**ADDENDUM NO. 1**

**DATE:** May 3, 2023

**PROJECT:** NC Department of Adult Corrections  
Tyrrell Prison Work Farm – Air Conditioning Installation  
SCO ID#22-25530-01A

**MD211**

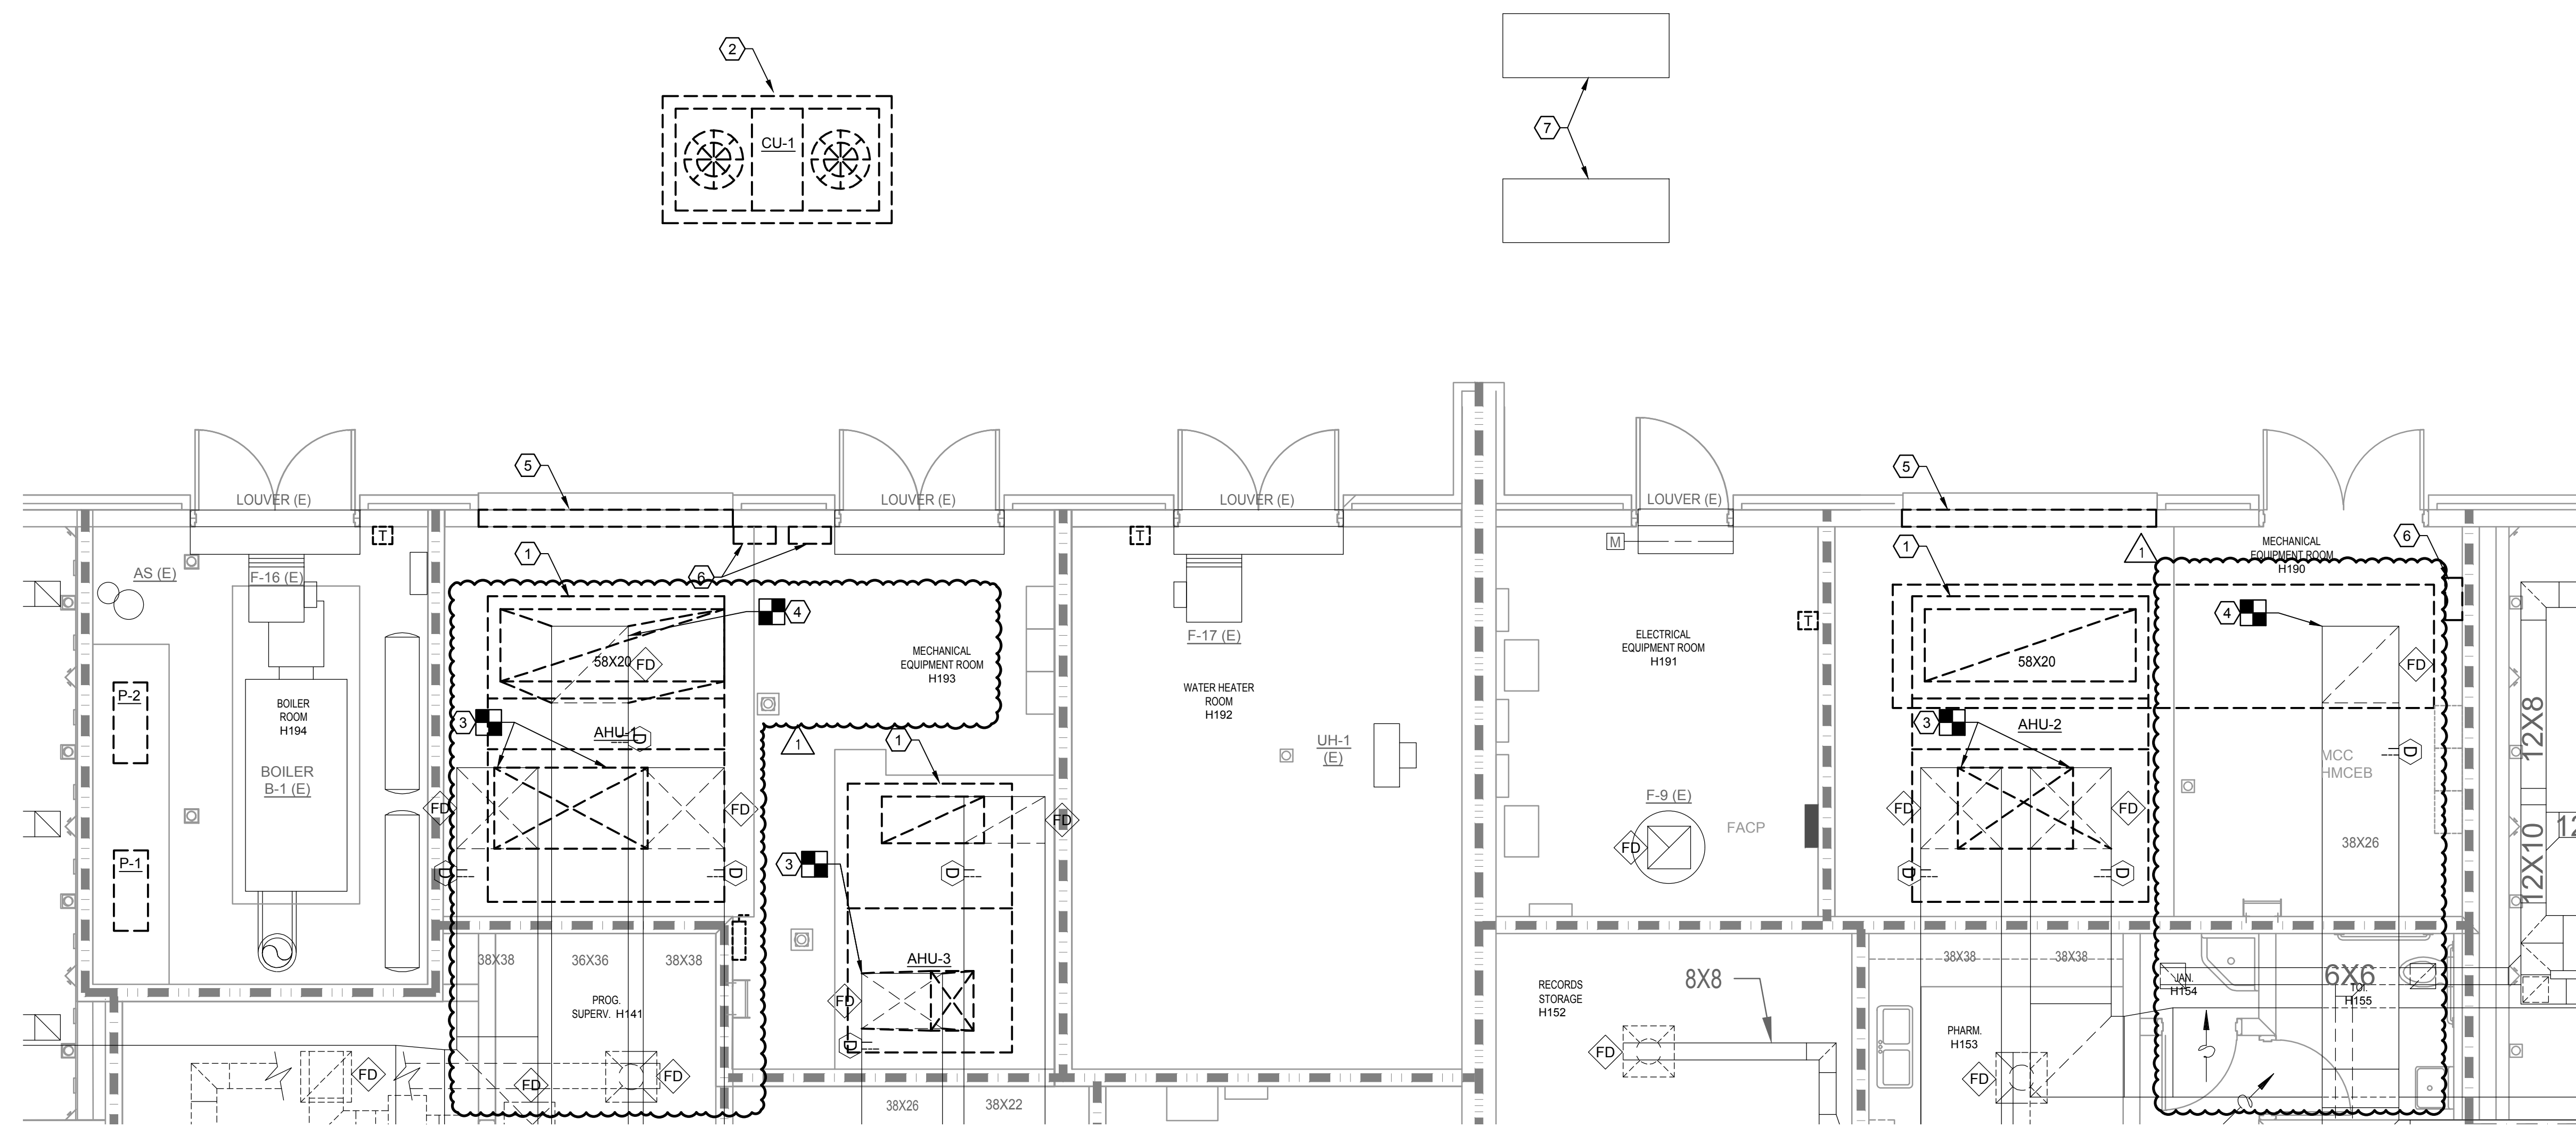
2. Please see attached April 26, 2023 Pre-Bid Meeting Minutes. The Pre-Bid Meeting Minutes shall become part of the contract documents.
3. Please reference Sheet MD211 FIRST FLOOR ENLARGED DUCTWORK DEMOLITION PLAN. Please see attached revised drawing indicating ductwork adjustments in the mechanical rooms.

M-211

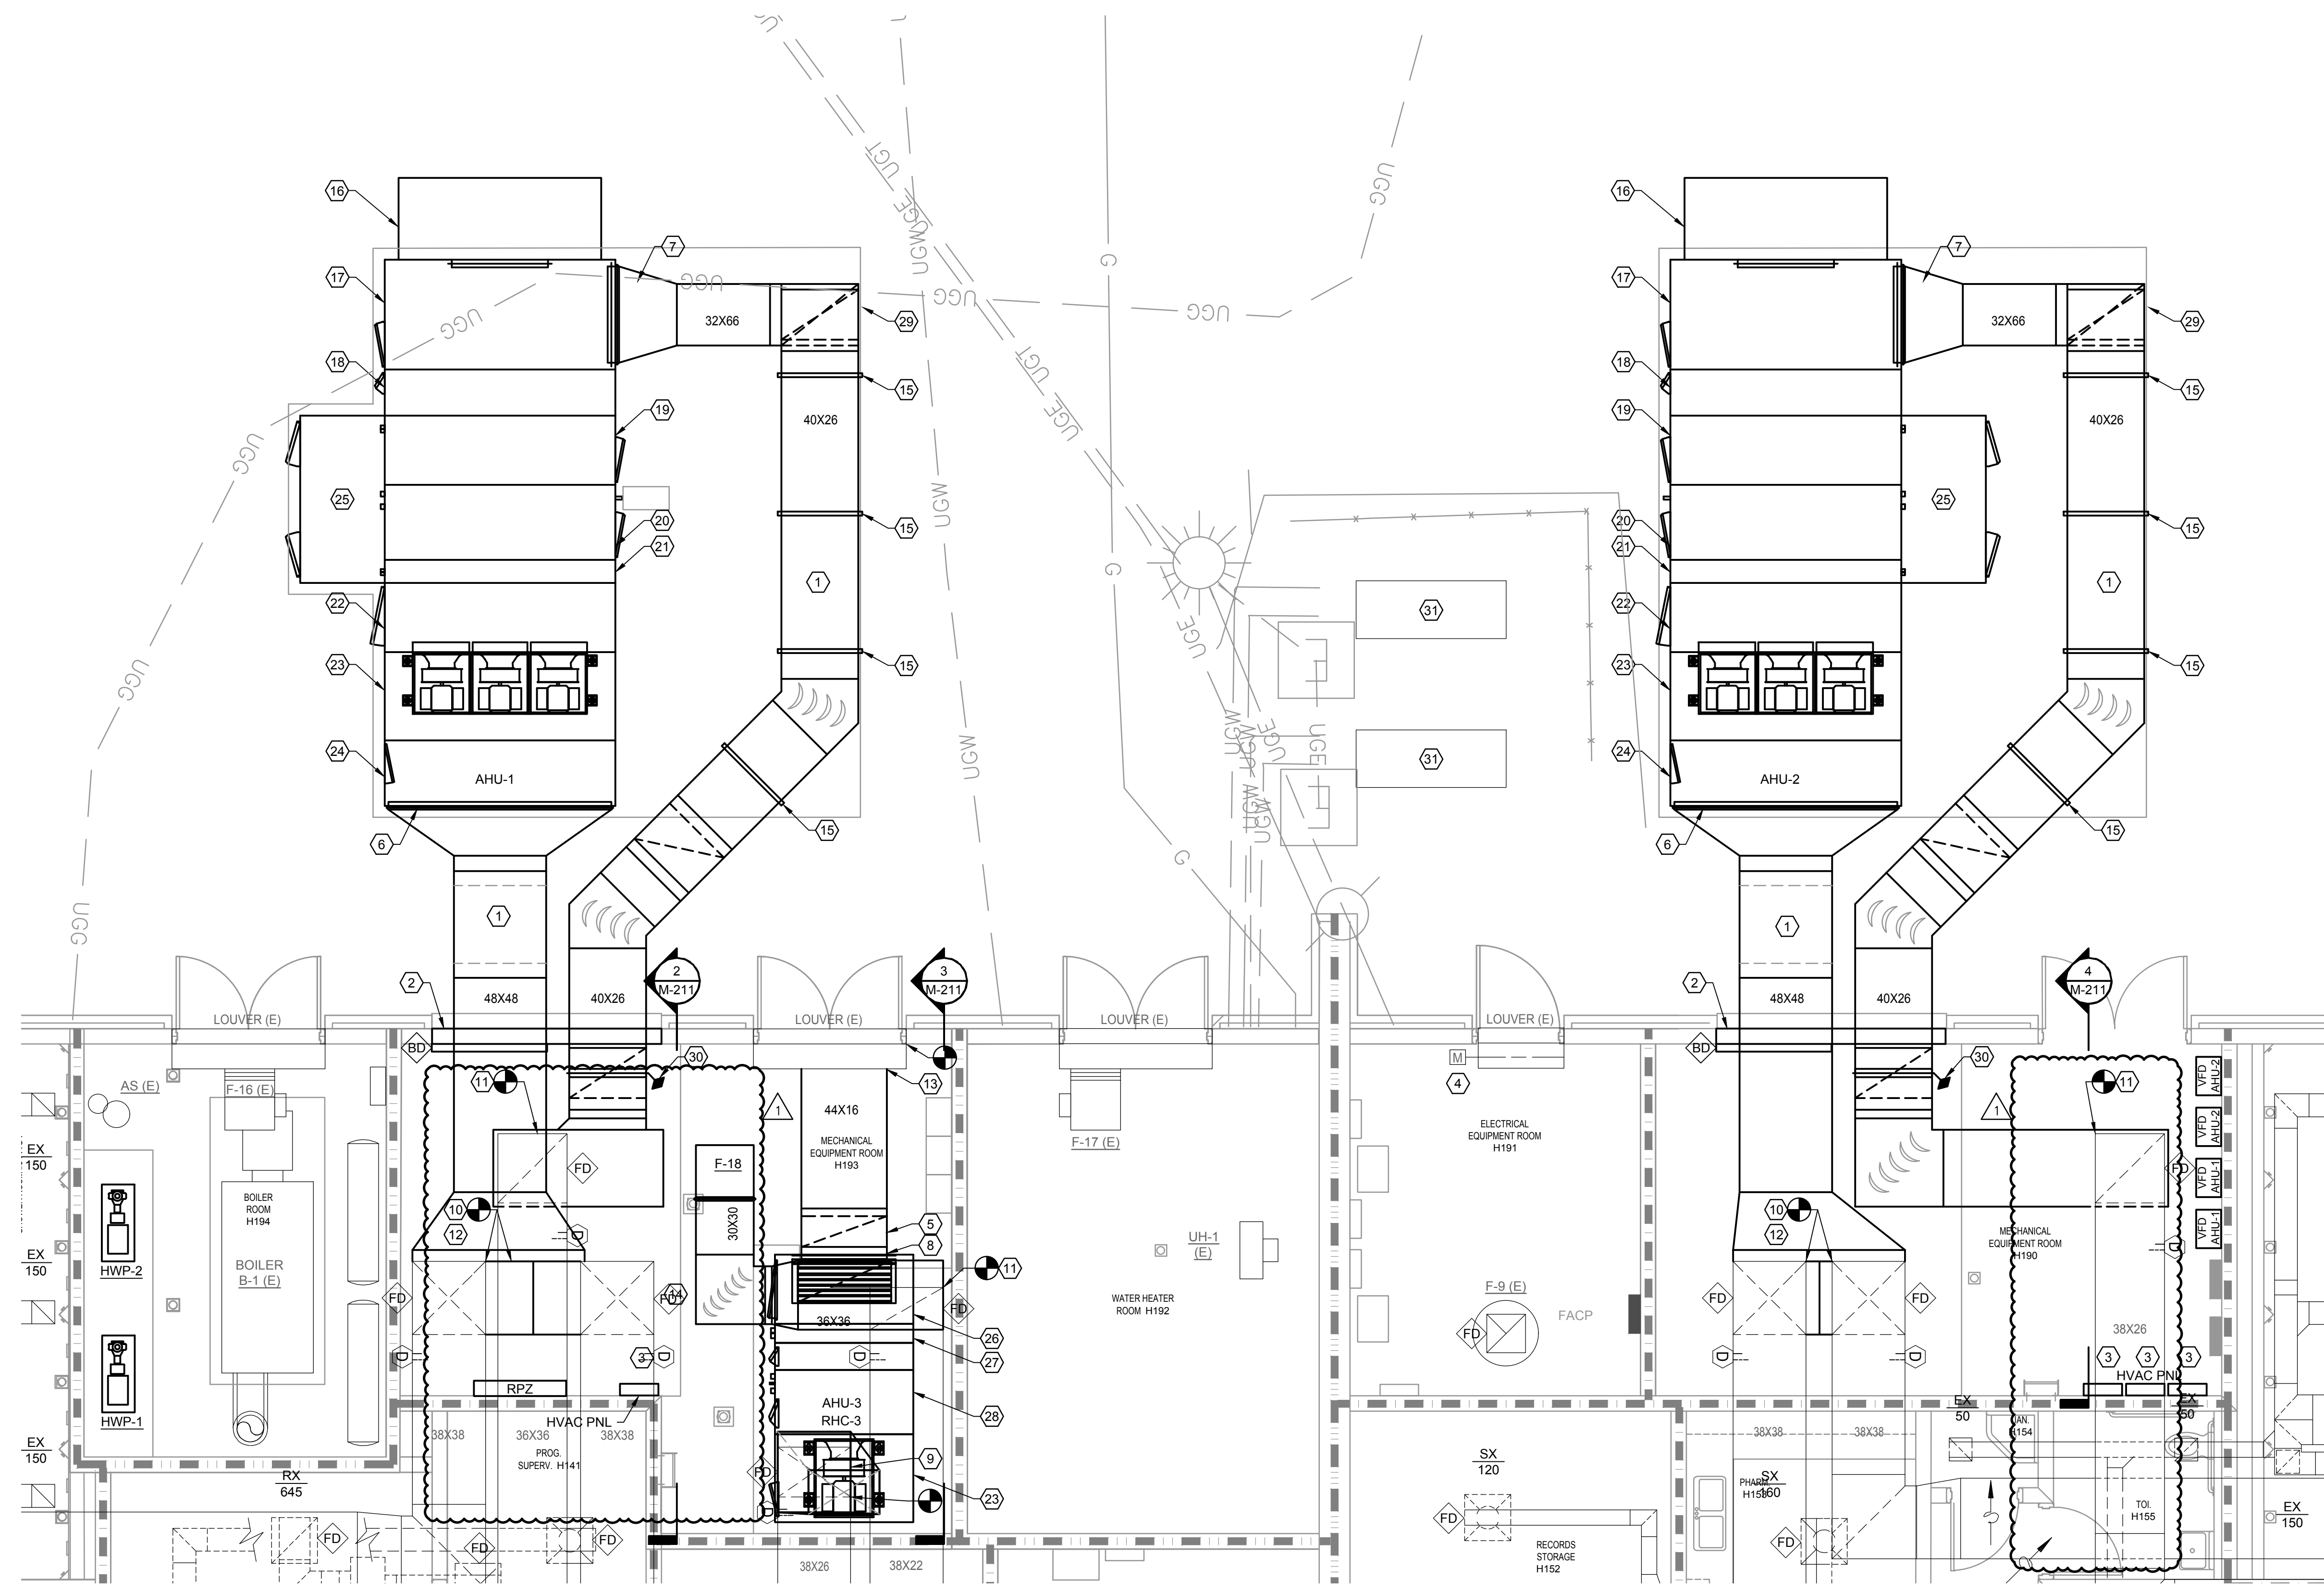
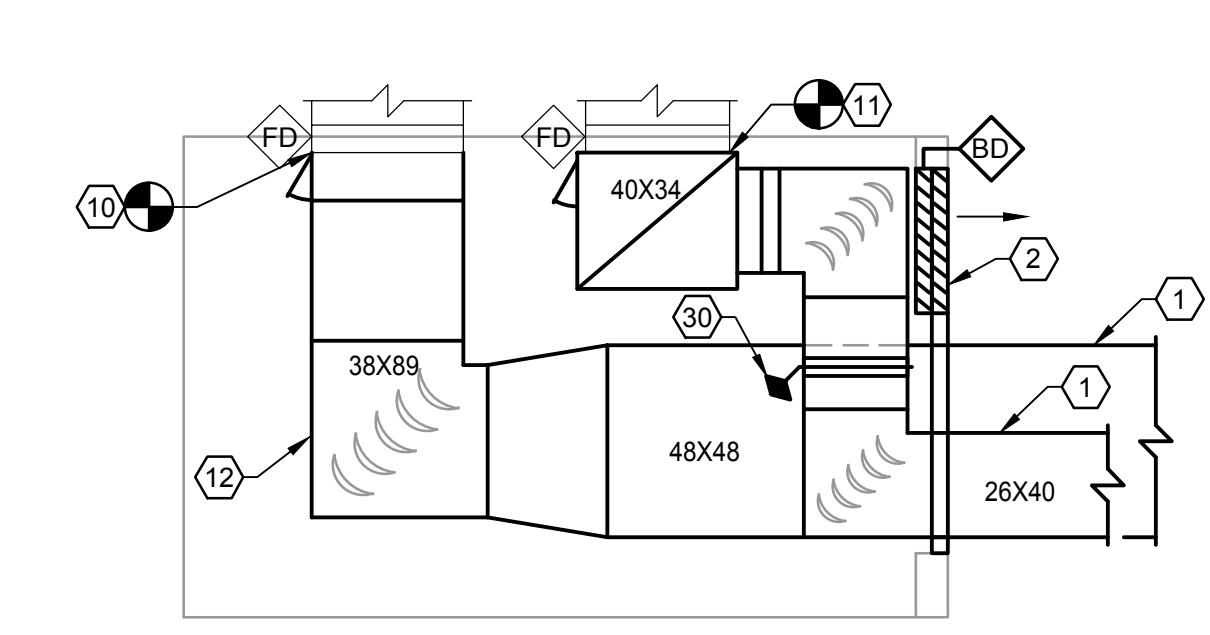
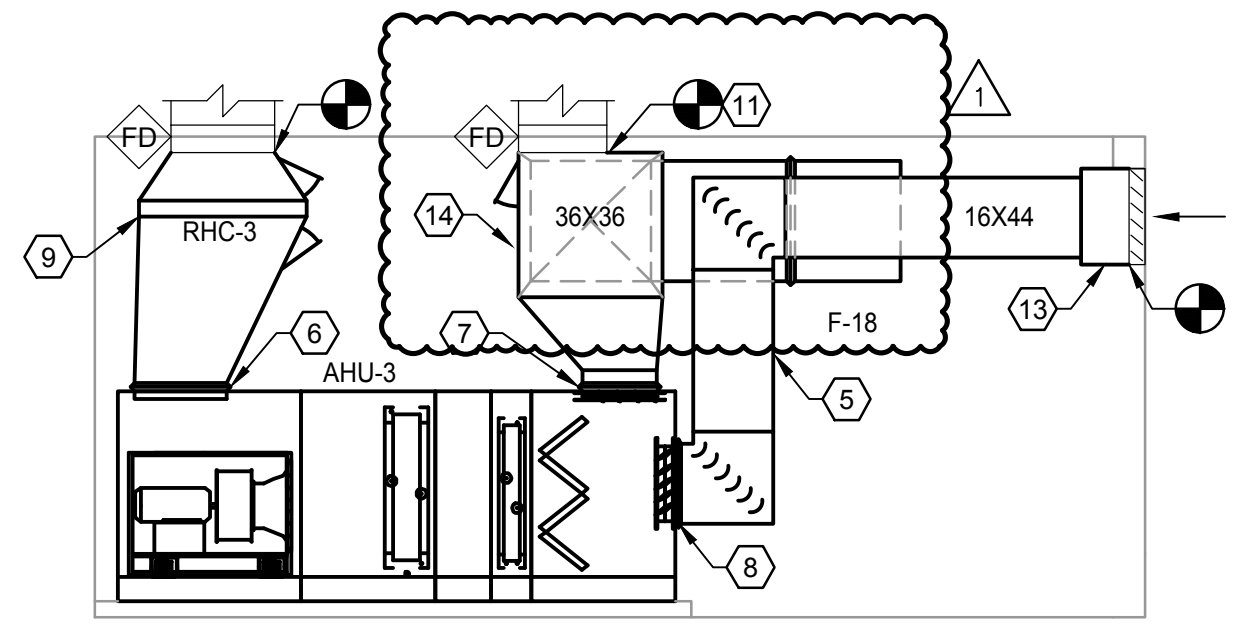
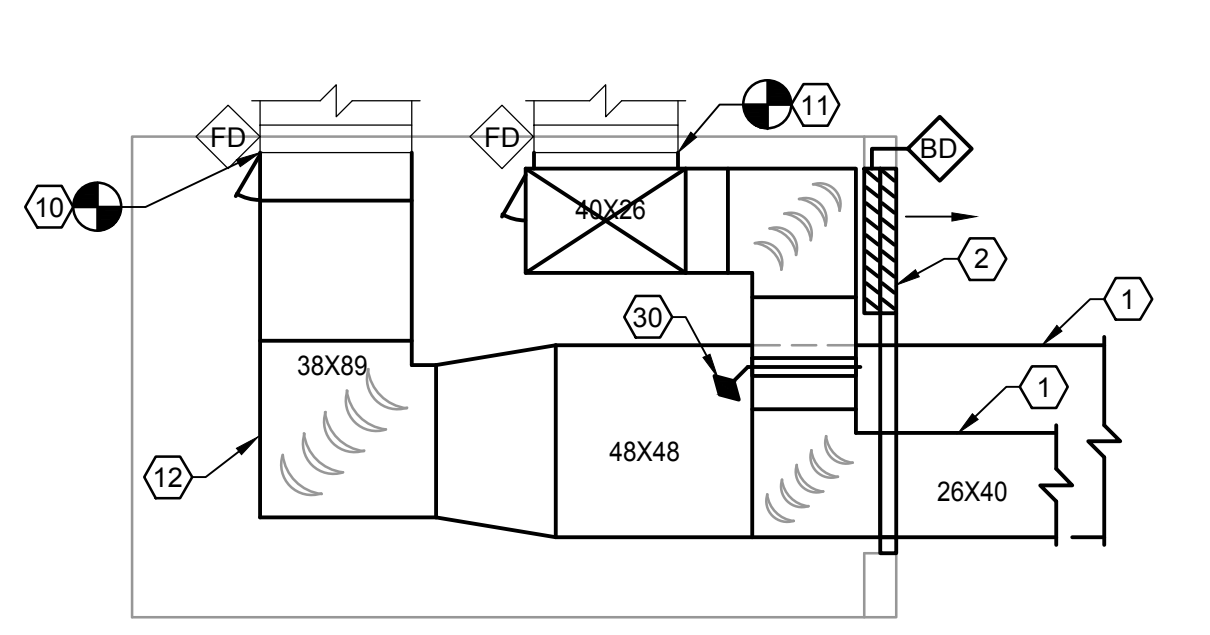
4. Please reference Sheet M-211 FIRST FLOOR ENLARGED DUCTWORK PLAN. Please see revised drawing indicating ductwork adjustments in the mechanical rooms.

5. Please reference Sheet M-211 FIRST FLOOR ENLARGED DUCTWORK PLAN, Boiler Room. Existing 1” make-up water backflow preventer is currently leaking. Contractor shall remove existing backflow, discard, and provide new 1” Watts 009-QT (or equal), reduced pressure zone backflow preventer. Provide with air gap fitting and route relief piping to floor drain.
